Trail map to a final Trails plan:

GTC Member Proposed Amendments to the Girdwood Trails Master Plan Jan 18 2022.  
Proposed changes may not be addressed in the order shown.

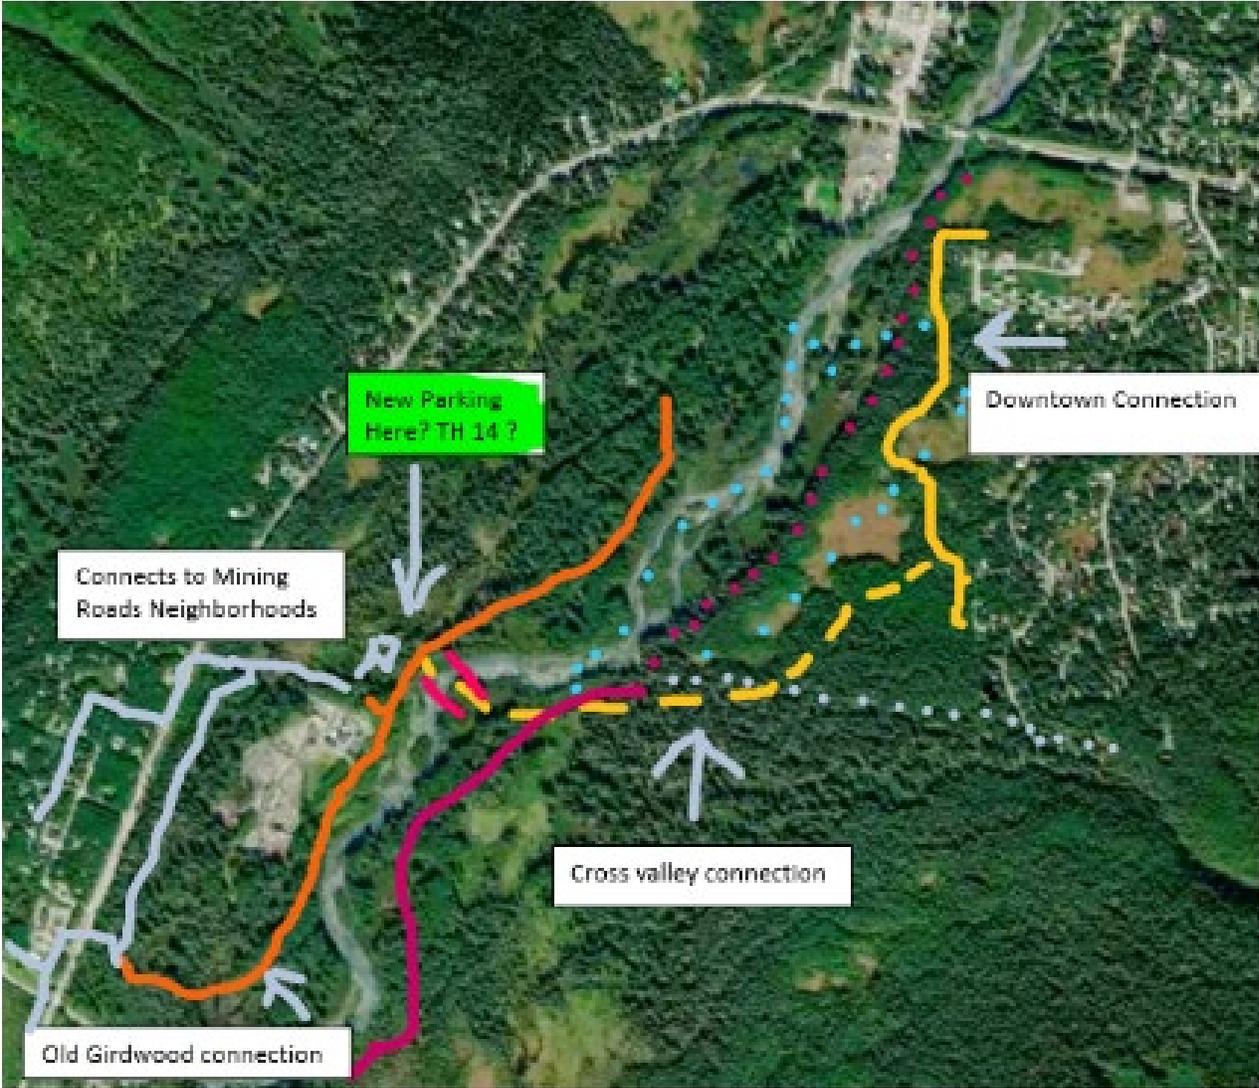
Proposed Motion: Add to the draft plan a new class 3 trail traversing parcel 6-036 and other nearby lands generally following the route that is indicated on the attached map.

Proposed Motion: Add to the draft plan a new site to locate bridge 1. Remove from the draft plan the old location of bridge 1. Select the new location of bridge 1 to correspond with the southern termination of the trail described in motion 1. (eg Amendment 11)

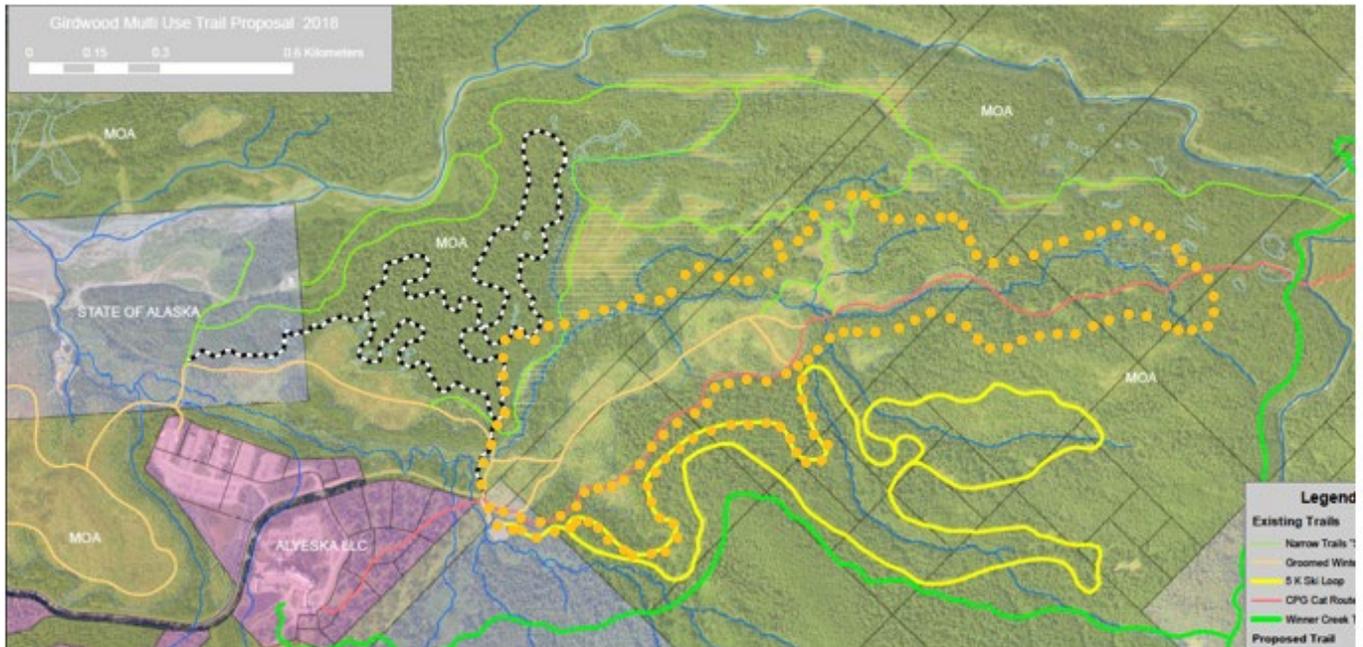
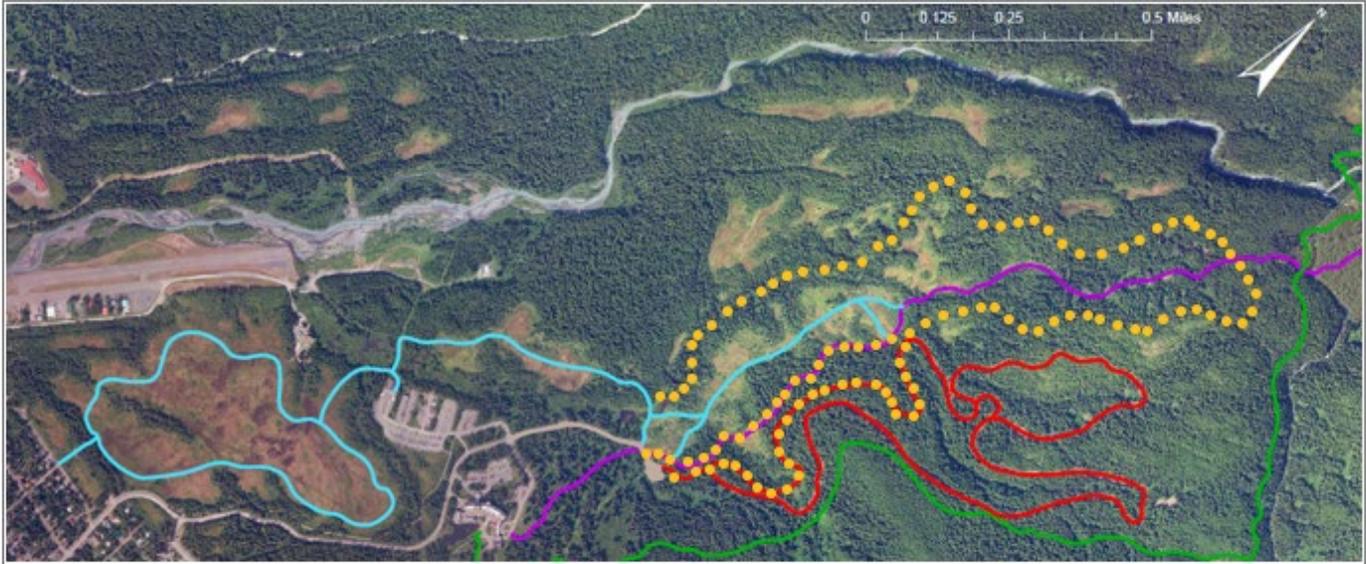
Proposed Motion: add back an Upper Valley Connector from the Forest Loop to the CPG CAT Track near the CAT Track Bridge. (see maps below)

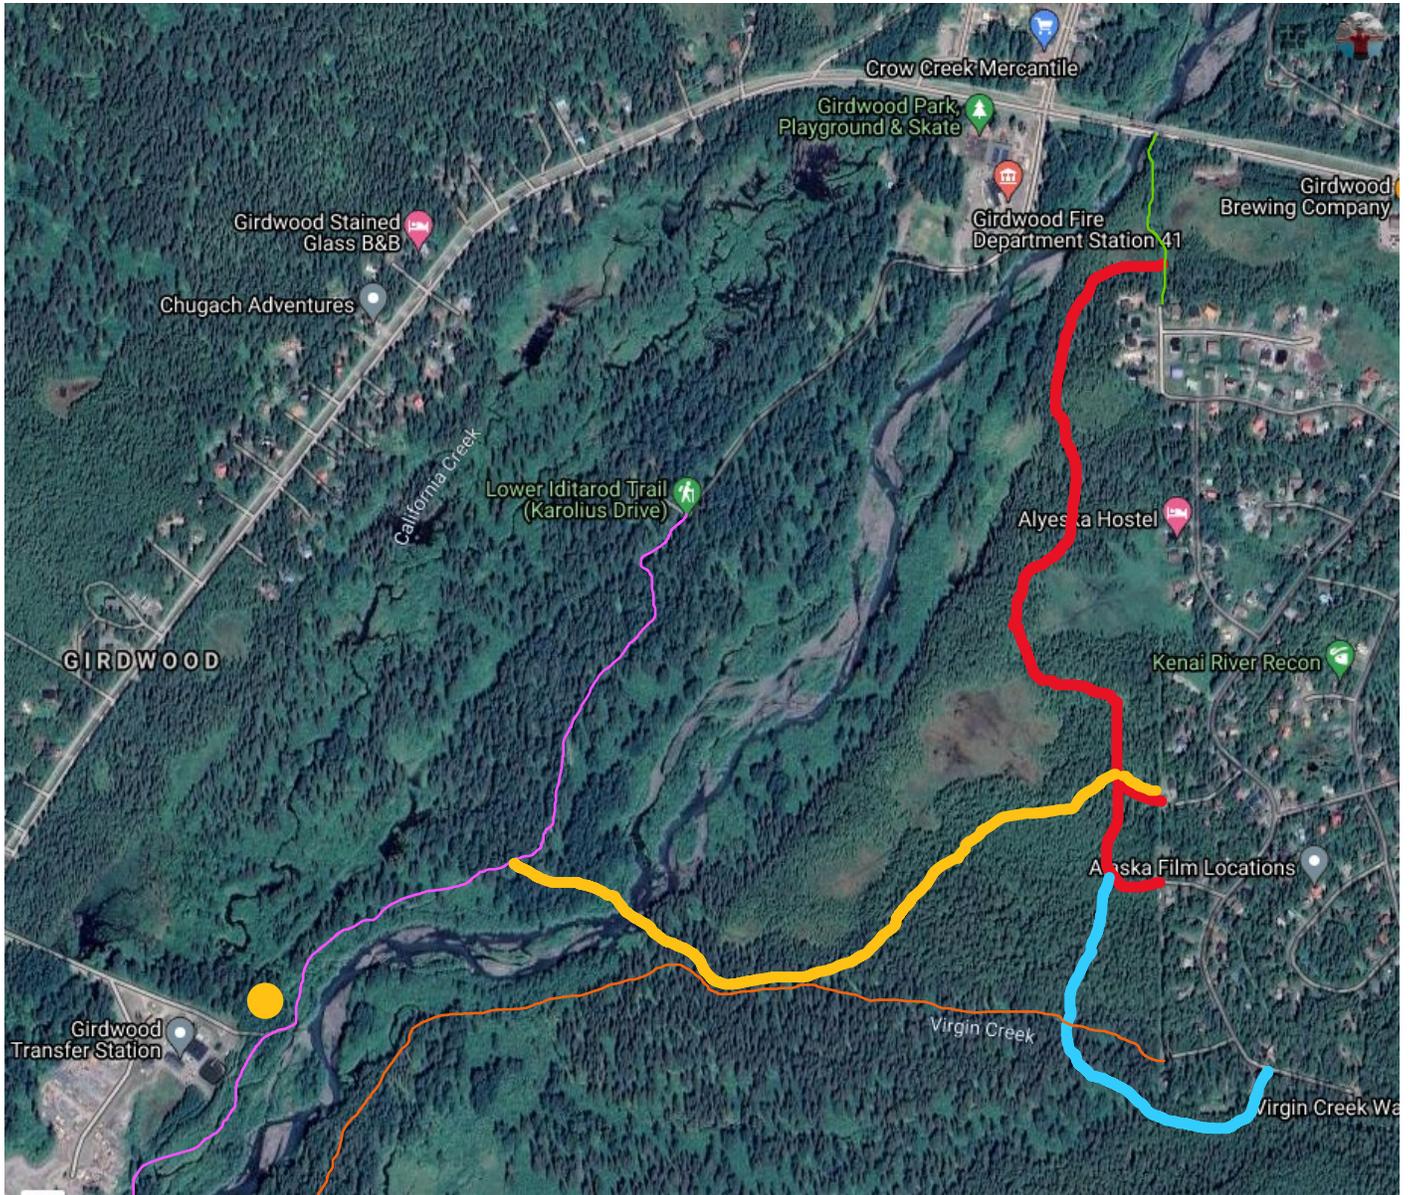
Delete B1 from the Draft Plan.

- With the Lower Danich Trail being Class 1 and the T2 connections to Wagon Trail being eliminated, funding for this bridge is not likely to be feasible. It would be better to direct our resources elsewhere.
